T10/05-079r3 SAS-1.1 Minimum XR/IR Receiver Signal Level for 3Gb SATA Mode

To: T10 Technical Committee
From: Barry Olawsky, HP (barry.olawsky@hp.com)
Date: 10 March 2005
Subject: T10/04-079r3 SAS-1.1 Minimum XR/IR Receiver Signal Level for 3Gb SATA Mode

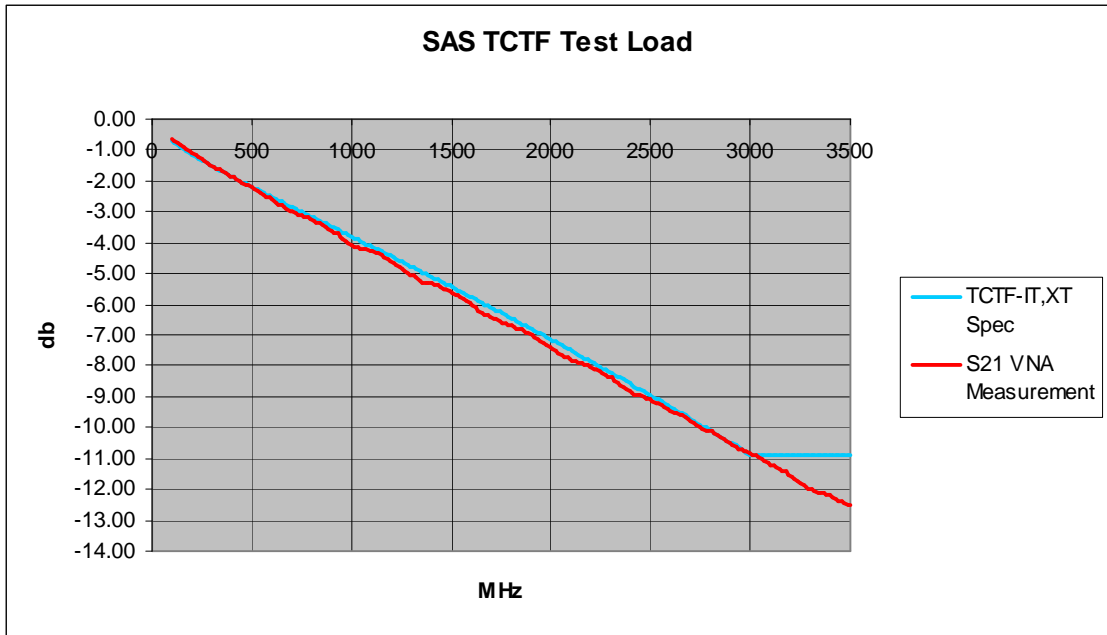
Add a subsection to "media specifications" defining the insertion loss characteristics of the low loss TCTF. The subsection shall include an insertion loss equation and graph that applies to 3Gb SATA gen2i transmitter devices ONLY. The below equation is obtained by scaling the 3Gb TCTF-IT equation such that 6dB insertion loss is obtained at 4.5GHz. The proposed graph is:

The proposed equation for the low loss TCTF is:

For 50 MHz < f <= 5.0 GHz:

|S₂₁(f)| of low loss TCTF test load <= -20 log₁₀(e) x ((3,58 x 10⁻⁶ x f^{0,5}) + (1,1 x 10⁻¹⁰ x f) + (1,82 x 10⁻²⁰ x f²)) dB

and, specifying a minimum ISI loss:

((|S₂₁(f = 300 MHz)| of low loss TCTF test load) - (|S₂₁(f = 1 500 MHz)| of low loss TCTF test load)) > 2,15 dB
